Re: Soil and Groundwater Investigation Work Plan addendum
Former BP Service Station #11117
7210 Bancroft Avenue
Oakland, CA
ACEHS Fuel Leak Case No. ~~820080356~~

**SUBJECT: Soil and Groundwater Investigation Work Plan Addendum
Former BP Service Station #11117
7210 Bancroft Avenue, Oakland, California
ACEHS Fuel Leak Case No. RO0000356**

URS	Project No. 38487251	PROPOSED SOIL BORING LOCATIONS	FIGURE 1
	ARCO Service Station #11117 7210 Bancroft Avenue Oakland, California

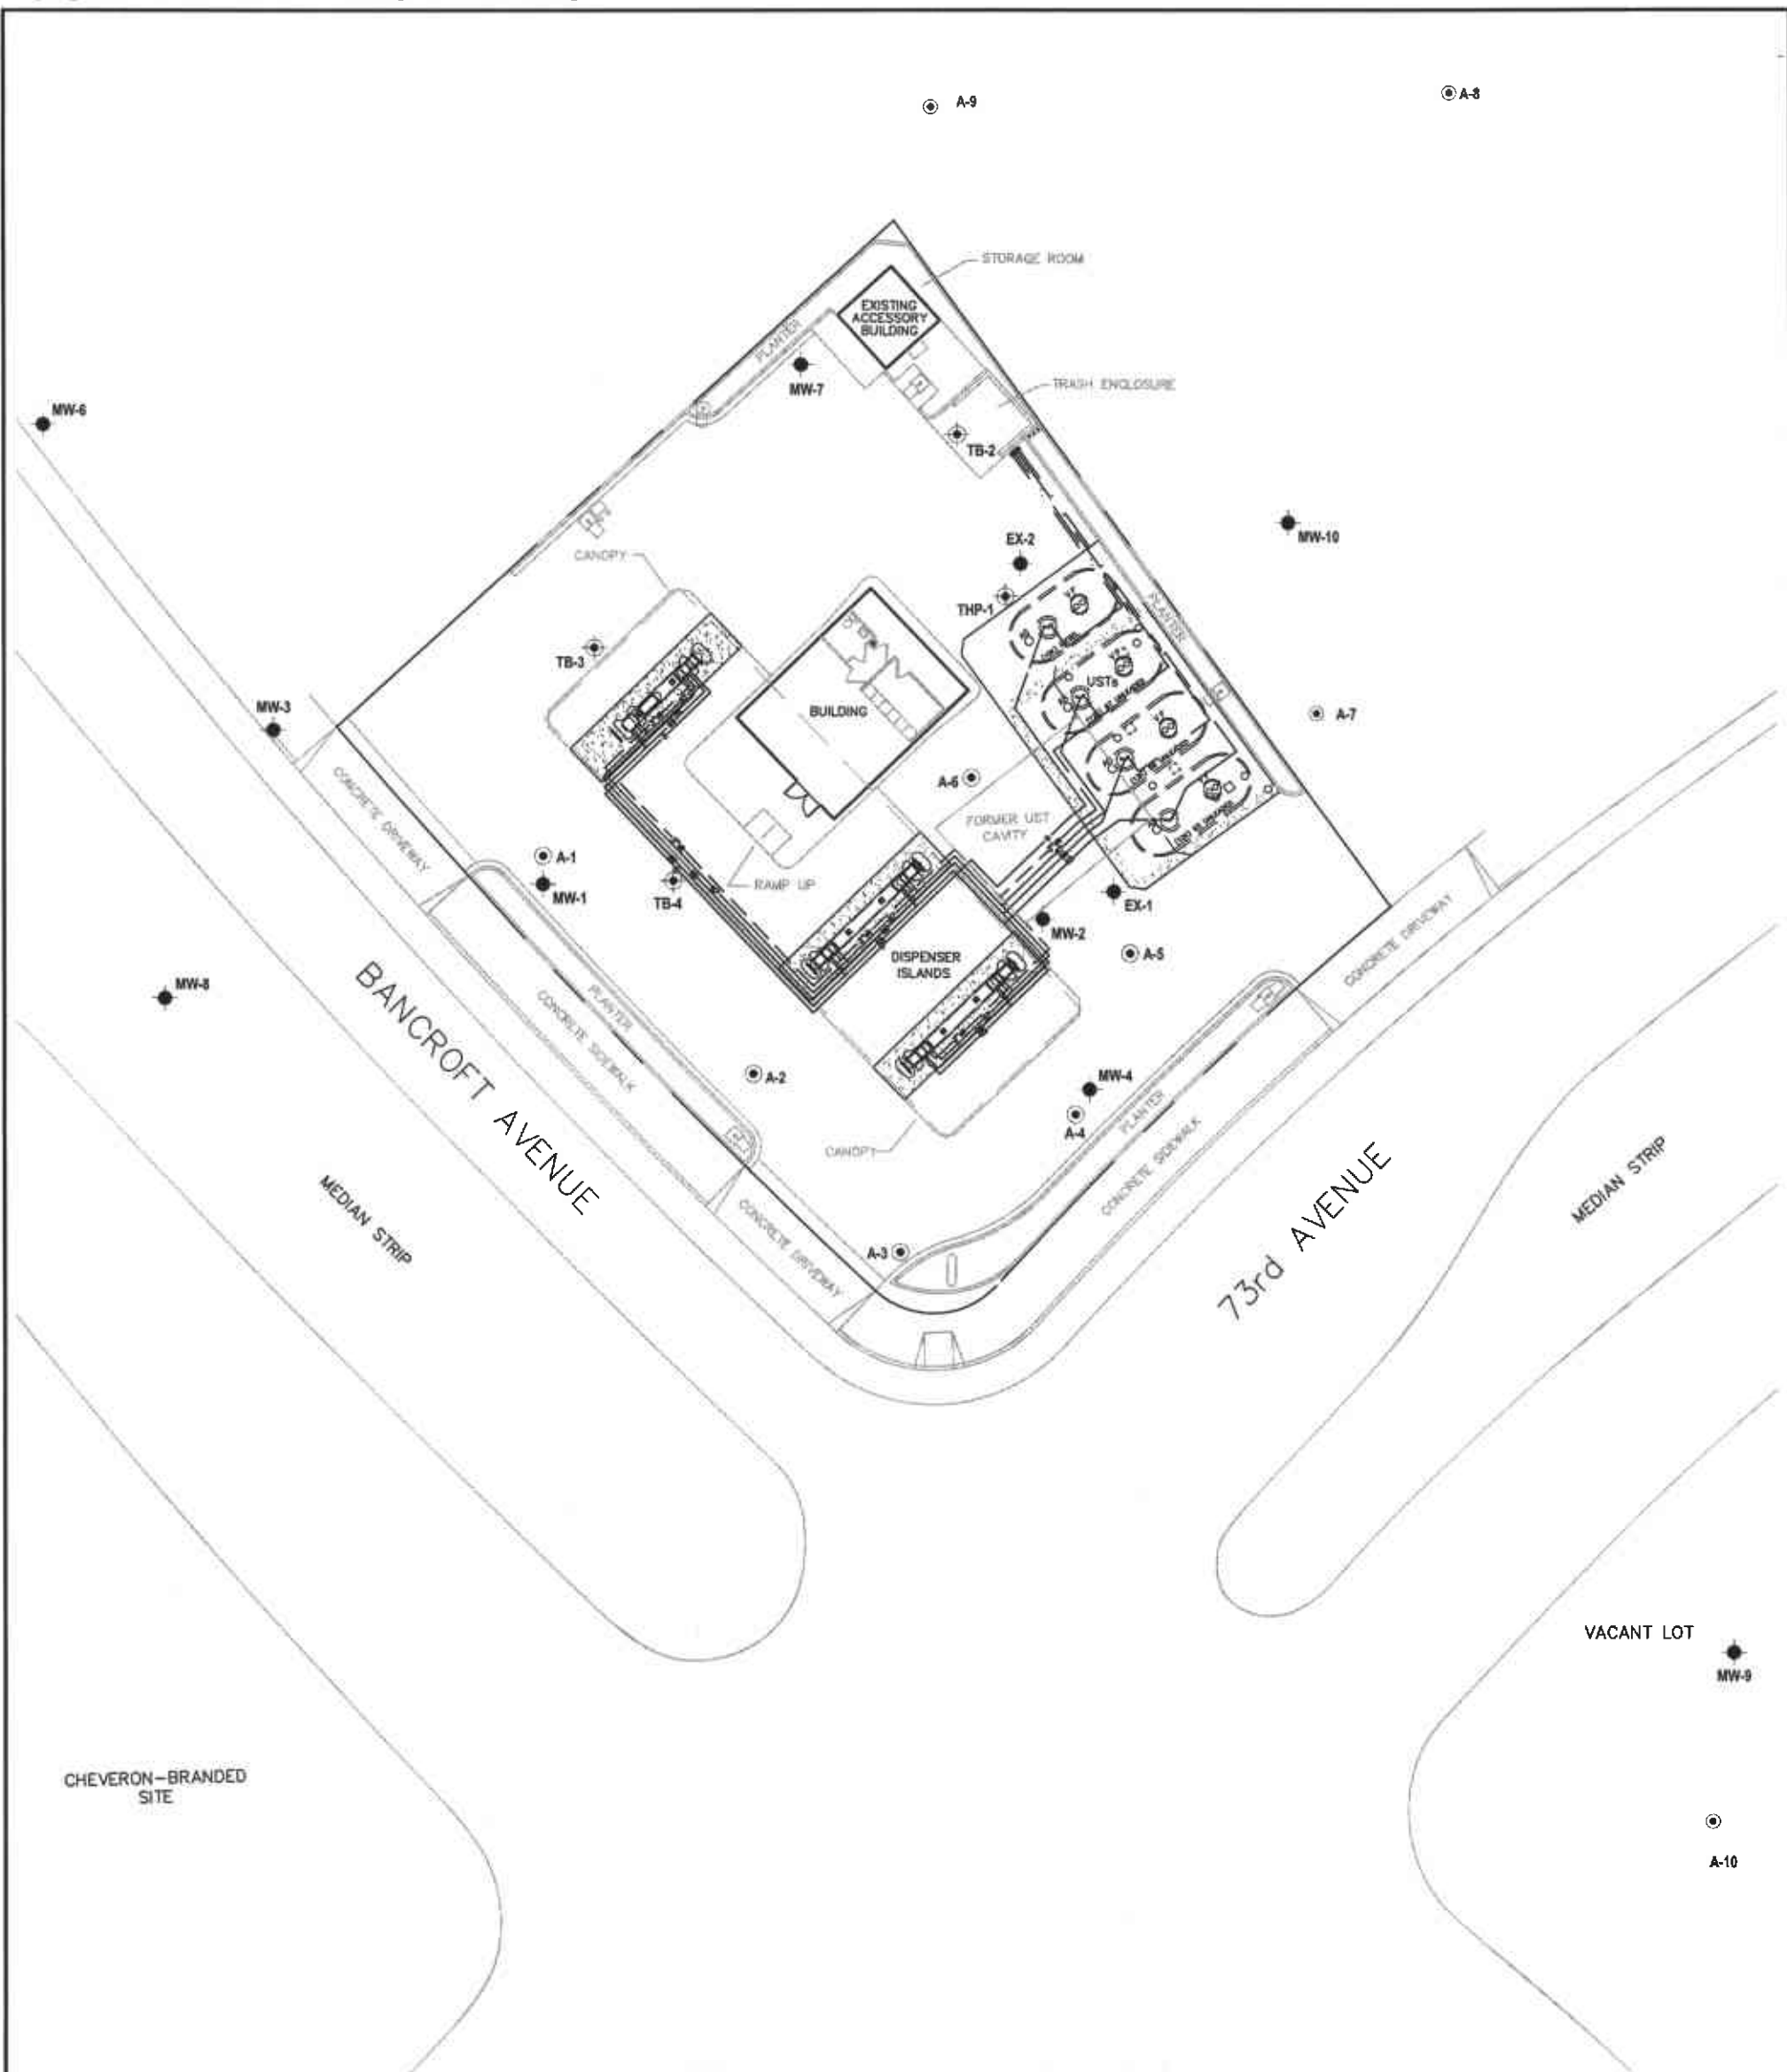
URS' proposed revised scope of work includes advancing six soil borings (A-1 through A-6), to help assess the lateral and vertical extent of petroleum hydrocarbons in soils in the identified source areas. Soil boring A-1 is proposed to assess the extent of hydrocarbons in soil in the vicinity of well MW-1 below 25 feet below ground surface (bgs), the total depth explored during the 1991 well installation. During historical low groundwater levels (greater than 25 feet bgs) groundwater concentrations in well MW-1 are elevated. Soil borings A-2 and A-3 are proposed to provide soil and groundwater data between wells MW-1 and MW-4. Soil boring A-4 is proposed in the vicinity of well MW-4. Soil boring A-5 and A-6 are proposed in the vicinity of the former and current USTs and product dispensers. The proposed soil boring locations are presented on Figure 1. Soil boring locations A-4 and A-5 may potentially be completed as air sparge and vapor extraction wells for possible future remediation. The completion of the remediation wells will be completed during phase two, dependant upon concentrations and lithology encountered during drilling activities. Remediation well installation details are provided in Phase Two - Section 2.2.2.1 Remediation Well Installation of this report.

URS' proposed revised scope of work includes advancing four off-site soil borings (A-7 through A-10), to help assess the extent of the groundwater plume in the area southeast and north to northeast of the source area (Figure 2). Soil borings A-7 through A-9 are proposed to assess the extent of hydrocarbons in soil and groundwater downgradient of the source area. Soil boring A-10 is proposed upgradient and in the vicinity of well MW-9 to further assess groundwater concentrations. The proposed off-site soil boring locations are presented on Figure 1. The final location of the off-site soil boring locations may be adjusted after a review the soil and groundwater results from the on-site phase of work. If relocation of the off-site boring locations is deemed necessary, a map with the new boring locations will be submitted to the ACEHS for approval.
